Addendum 02

DOCUMENT 00 91 00

DATE: January 29, 2026

PROJECT: Tipp City Seniors New Addition
528 North Hyatt Street
Tipp City, Ohio 45371

2 FIRST FLOOR LIGHTING PLAN - UNIT A
1/8" = 1'-0"

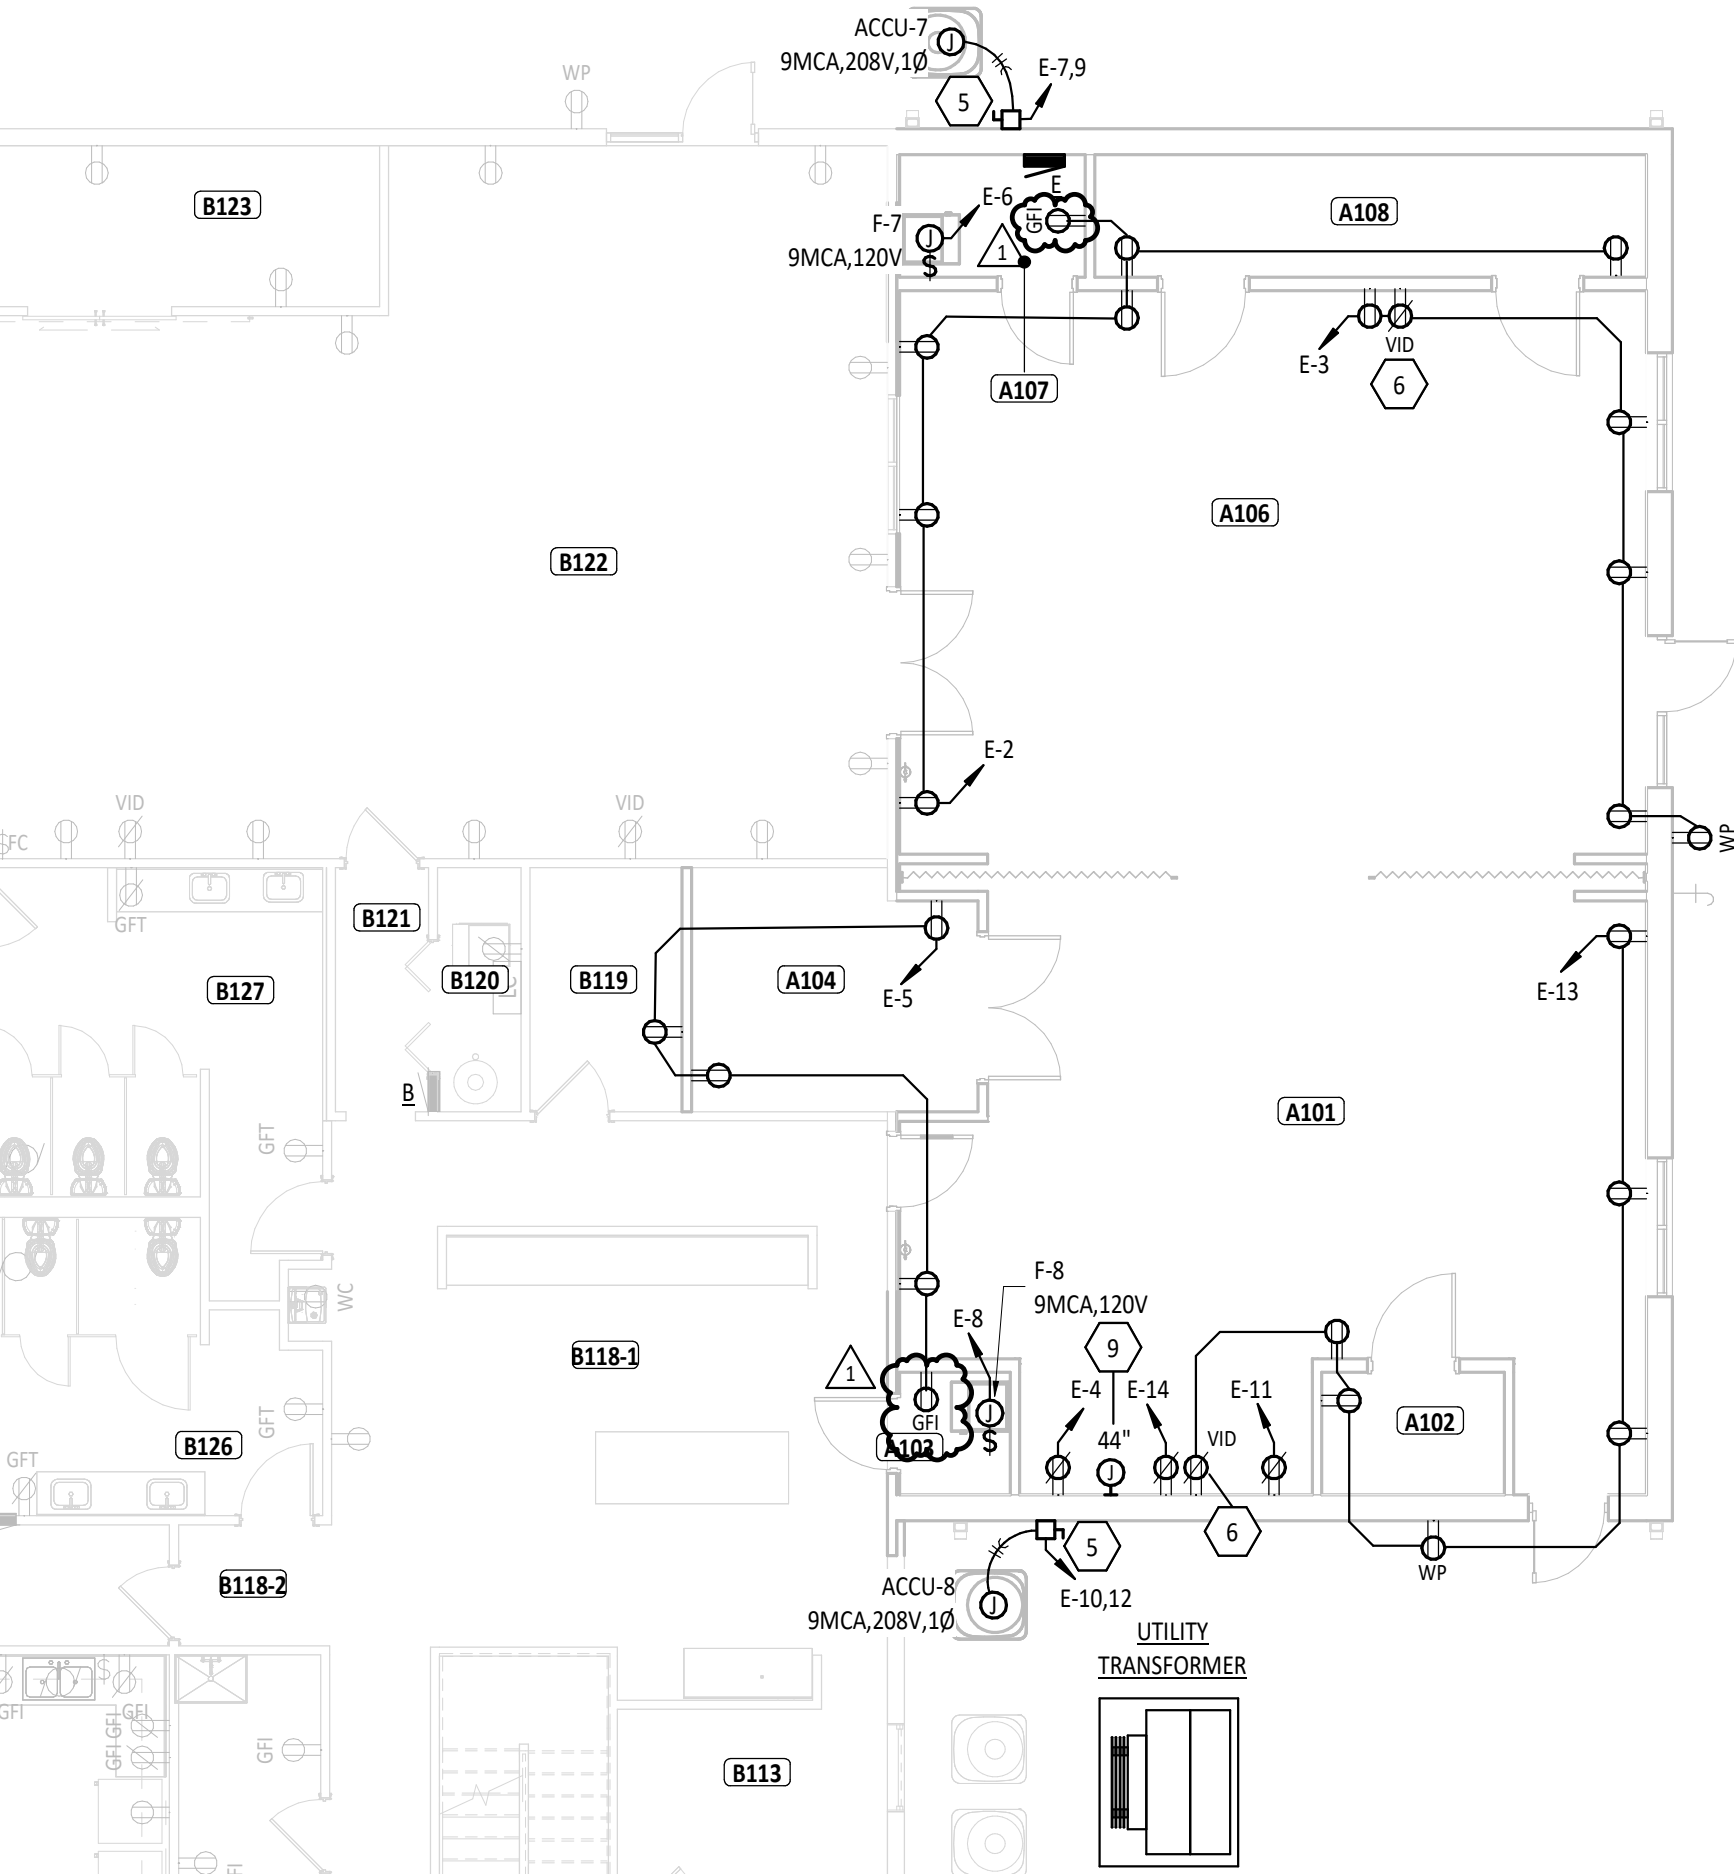
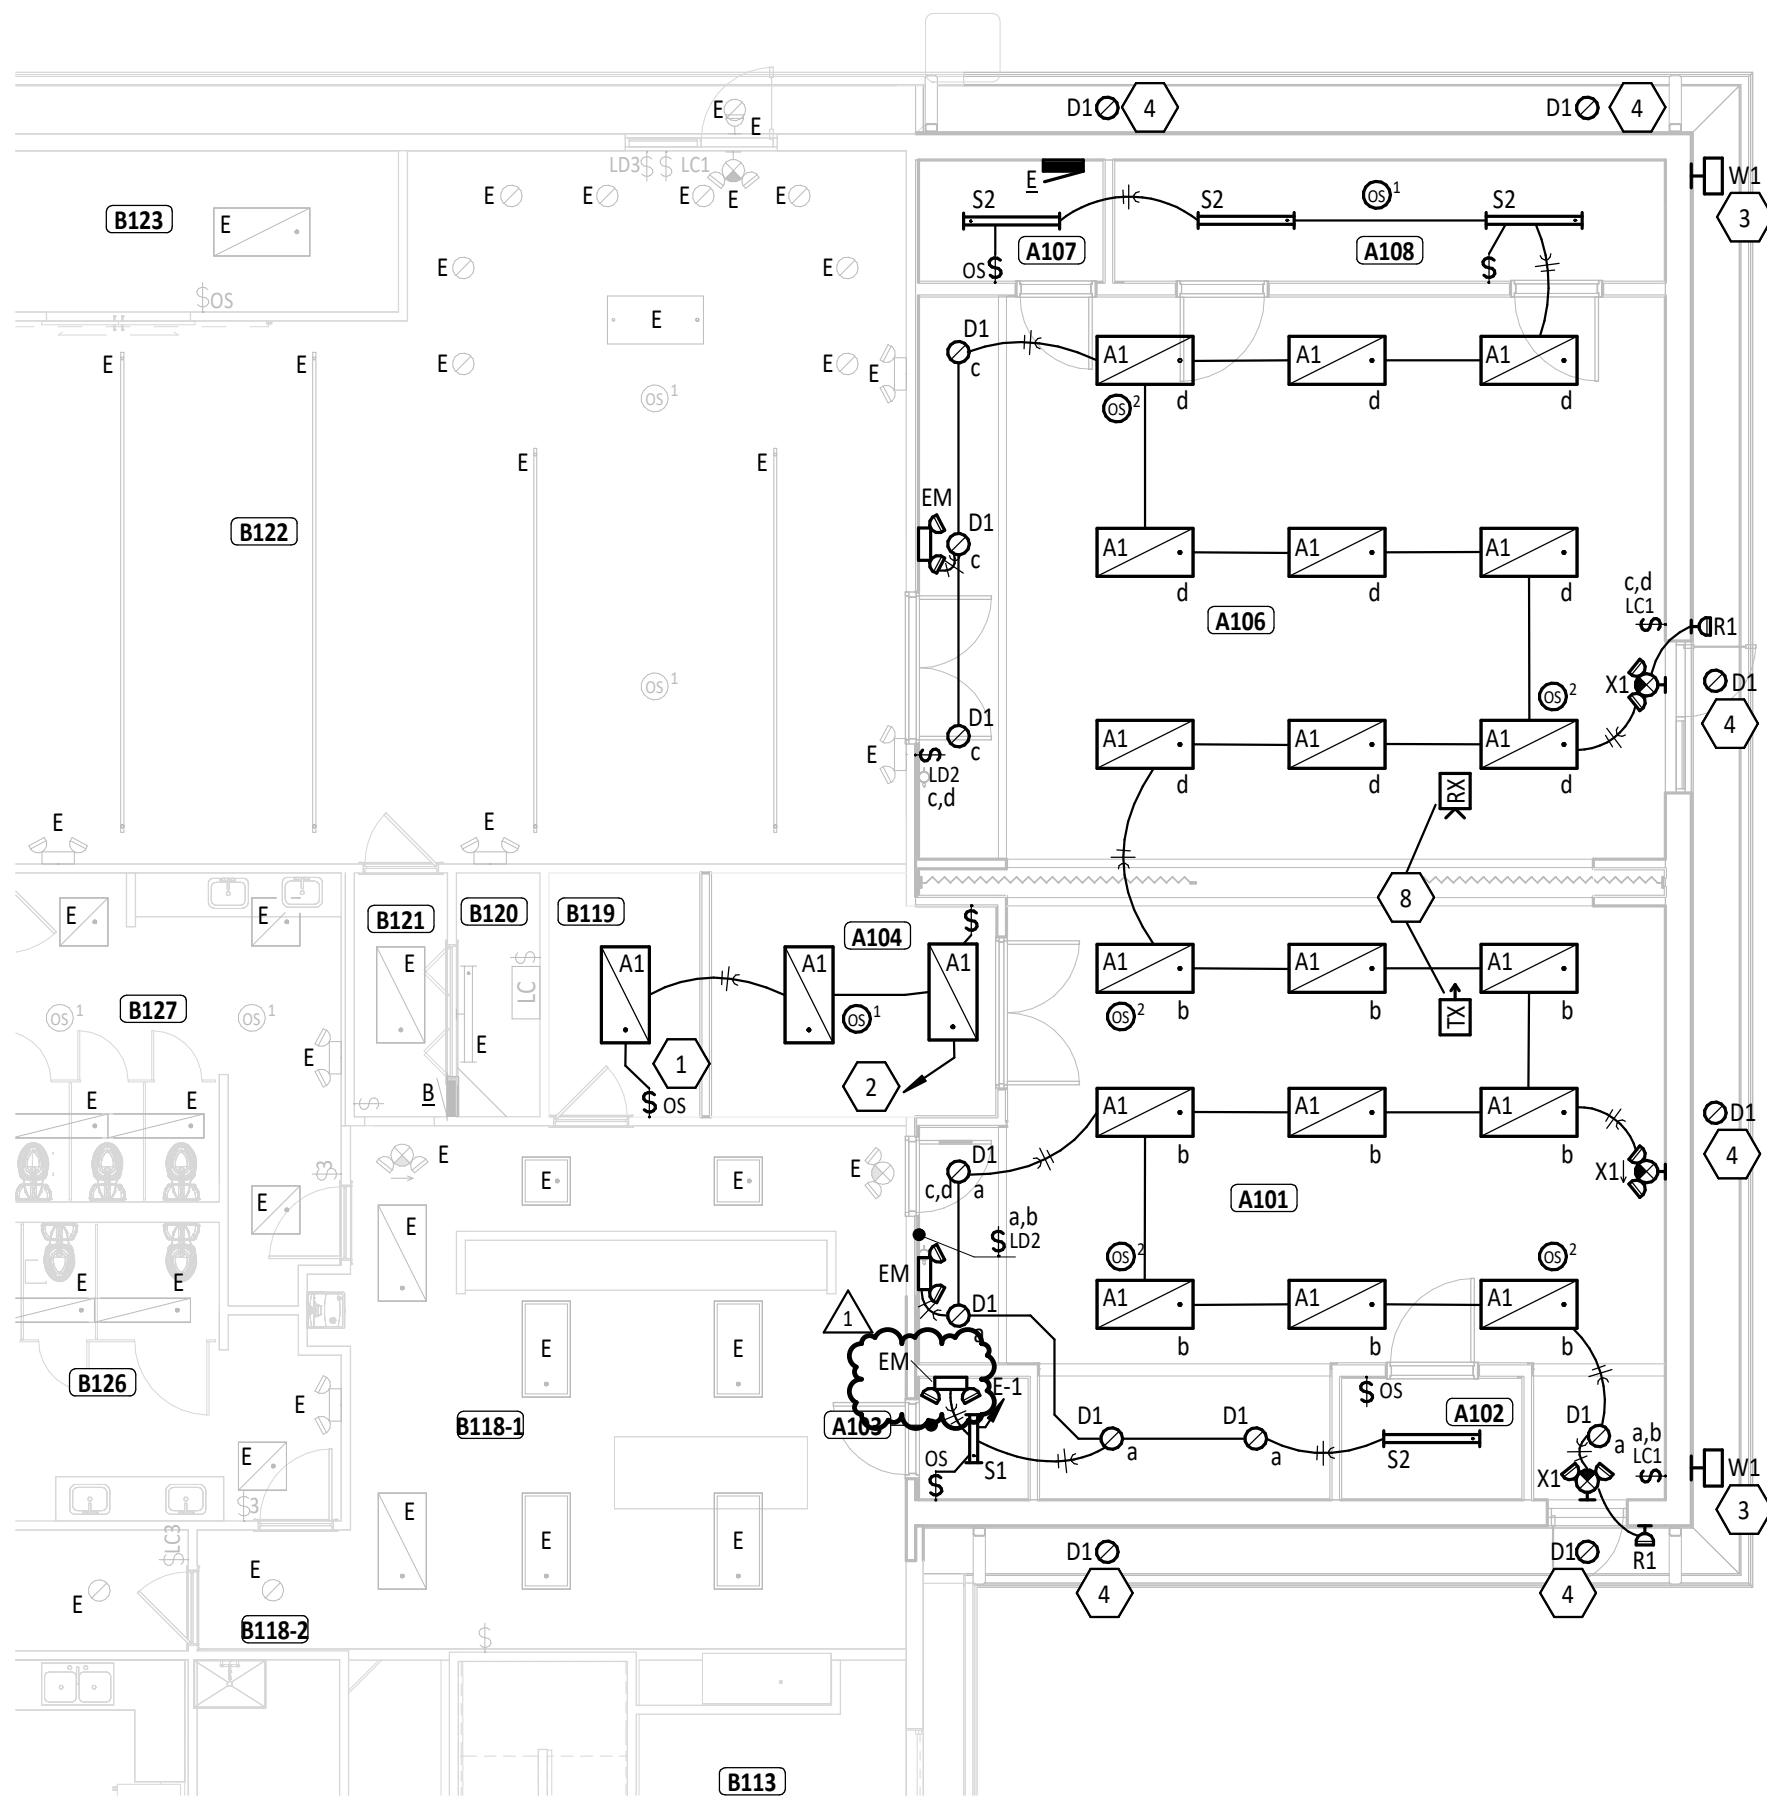
8. Drawing Sheet E3.1 Detail 2 First Floor Lighting Plan – Unit A:
 - a. Add one emergency battery light type 'EM' in room A103.
9. Drawing Sheet E3.1 Detail 3 First Floor Power Plan – Unit A:

- a. Change one standard duplex receptacle to a GFCI type in rooms A107 and A103.
10. Drawing Sheet E4.1 Electrical One-Line Diagram:
 - a. Remove one existing disconnect from one-line. There are only five existing disconnects.

1 FIRST FLOOR MECHANICAL PLAN - UNIT A
1/8" = 1'-0"

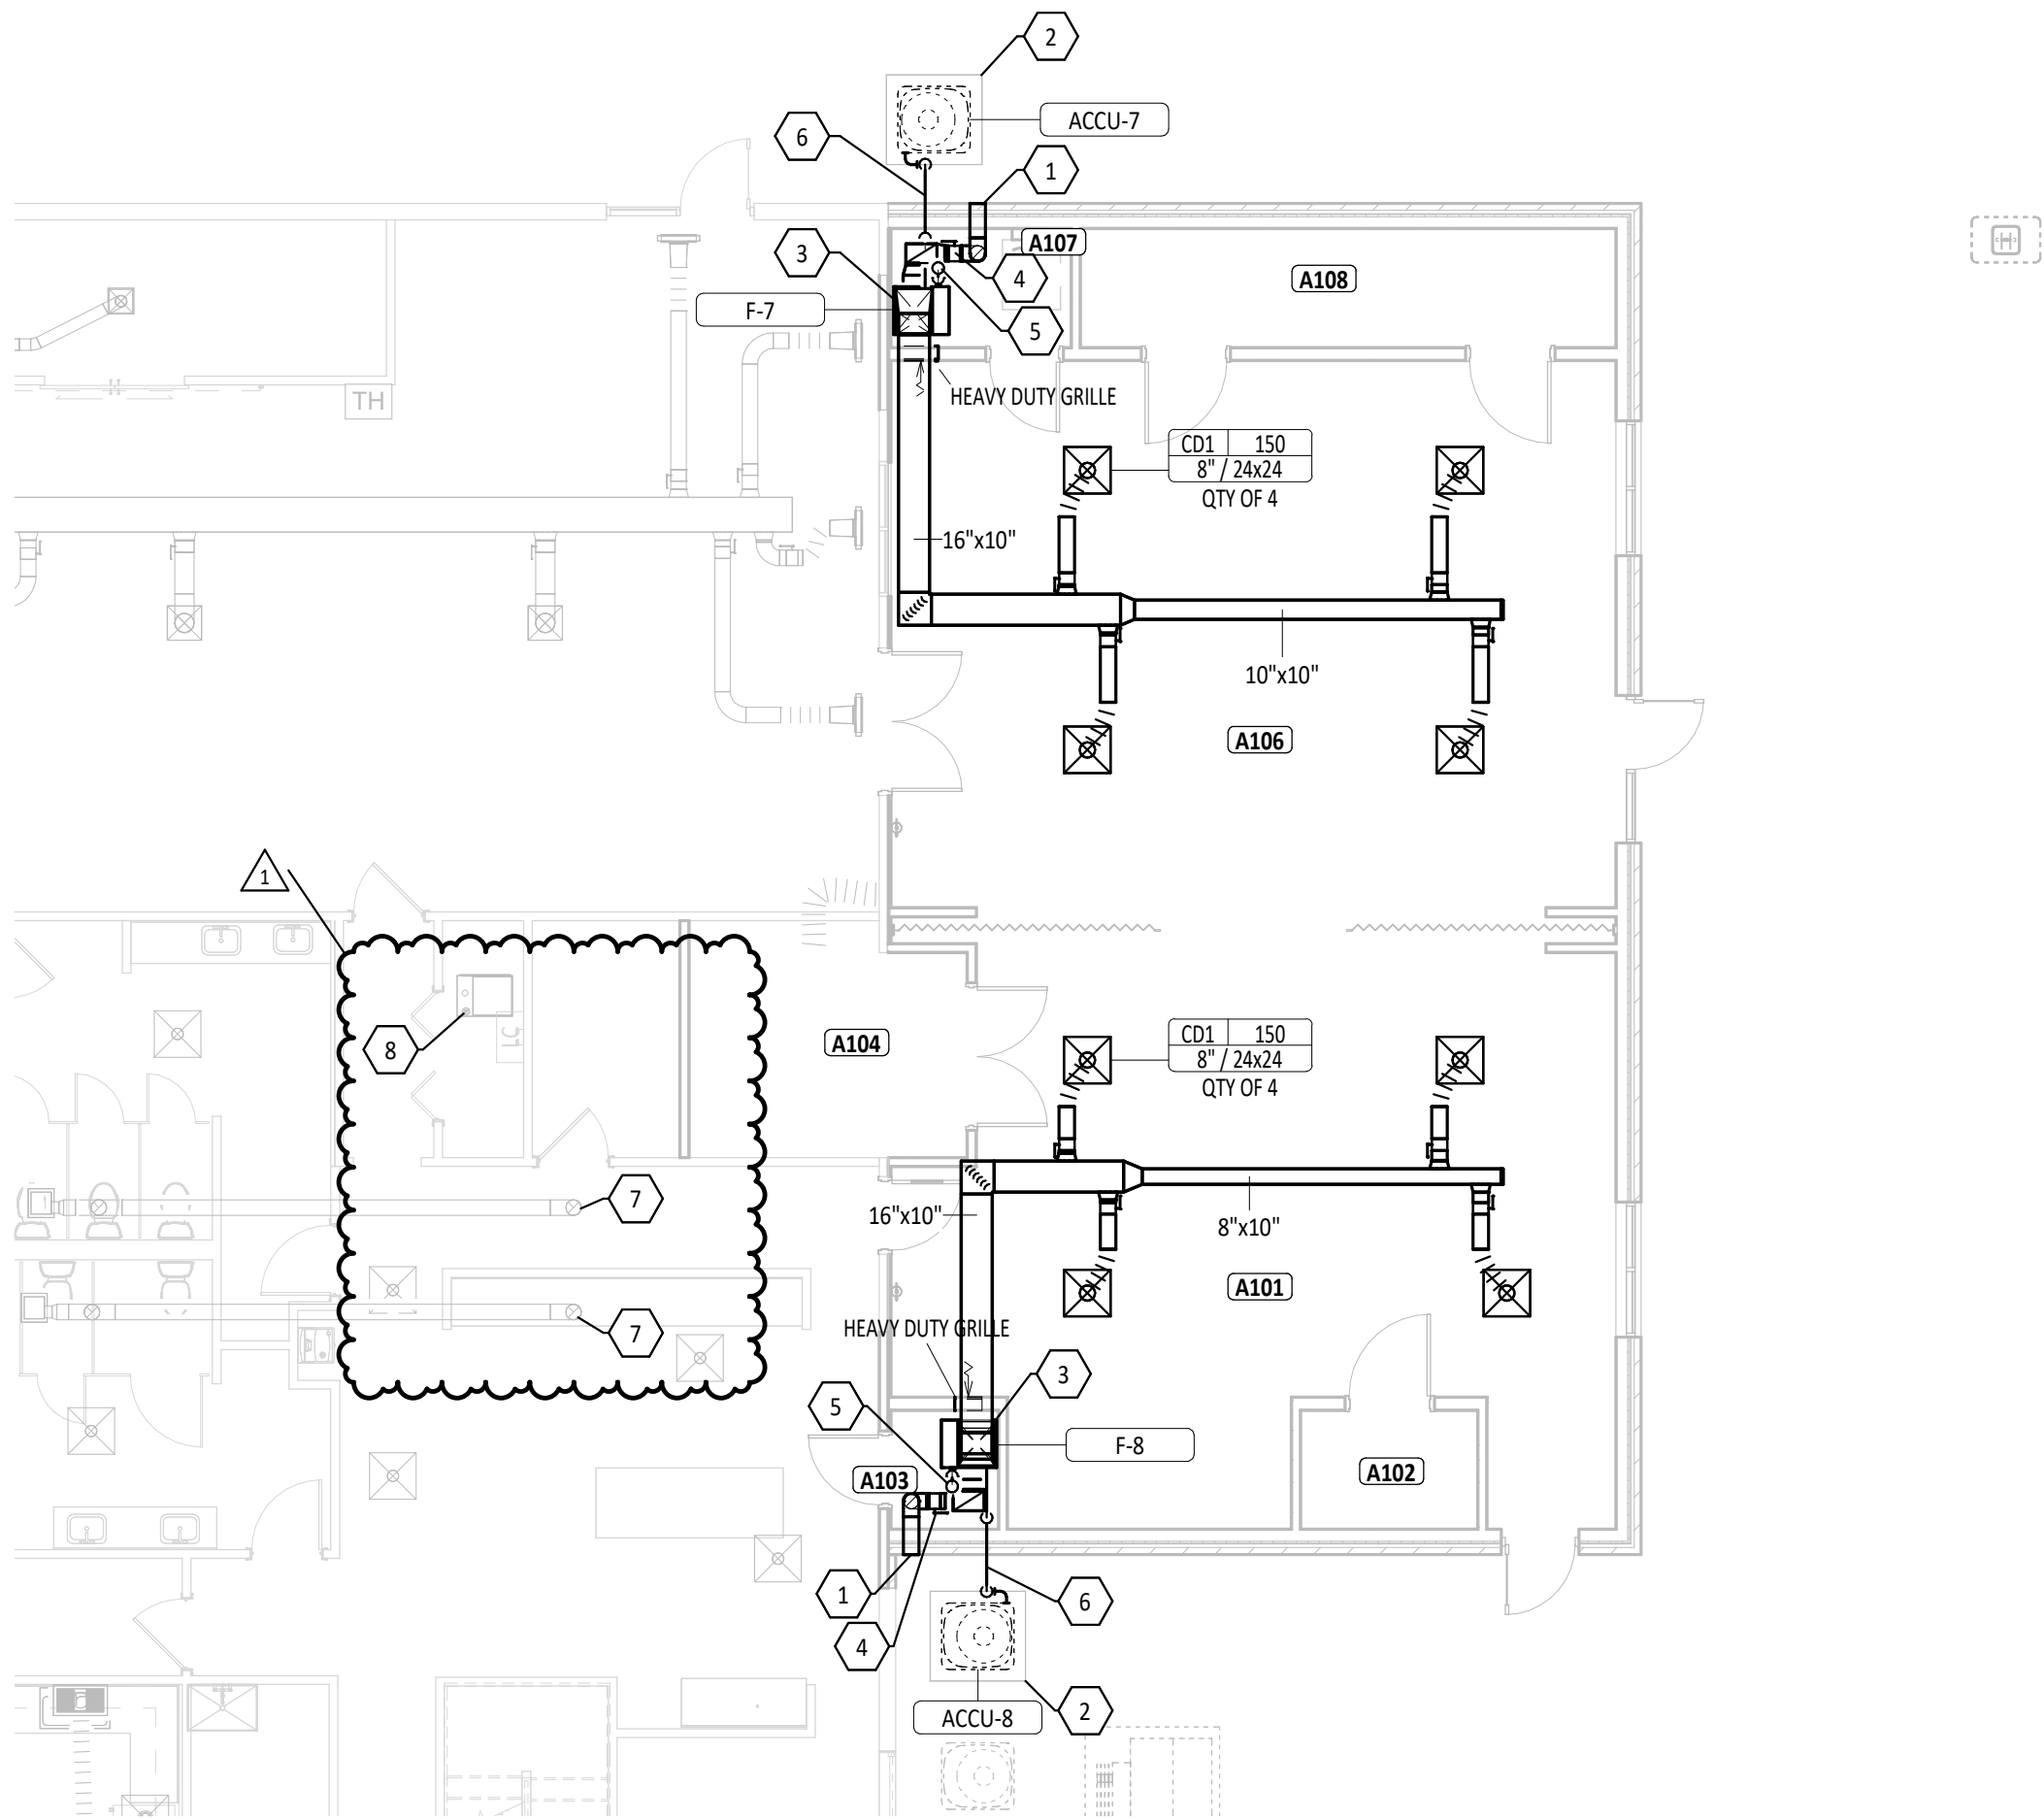
4. Drawing Sheet A7.1 Reflected Ceiling Plan – Unit A:
 - a. Added blown insulation to bulkhead details 2/A7.1 and 3/A7.1
5. Drawing Sheet M2.1 First Floor Mechanical Plan – Unit A:

- a. Added existing furnace flue and restroom exhaust fan vent roof penetrations
6. Drawing Sheet P2.1 First Floor Plumbing Plan – Unit A:
 - a. Added existing sanitary vent roof penetration

7	APPROXIMATE LOCATION OF EXISTING RES/ROOM EXHAUST FAN ROOF VENT. EXTEND THROUGH THE NEW ROOF AS REQUIRED AND TERMINATE WITH NEW ROOF CAP. SEAL ROOF PENETRATION WATER TIGHT. COORDINATE PENETRATION WITH GENERAL CONTRACTOR. FILED VERIFY DUCT SIZE AND LOCATION.
8	APPROXIMATE LOCATION OF EXISTING FURNACE FLUE ROOF CAP. EXTEND THROUGH THE NEW ROOF AS REQUIRED AND TERMINATE WITH NEW ROOF CAP. SEAL ROOF PENETRATION WATER TIGHT. COORDINATE PENETRATION WITH GENERAL CONTRACTOR. FILED VERIFY FLUE SIZE, MATERIAL, AND LOCATION.
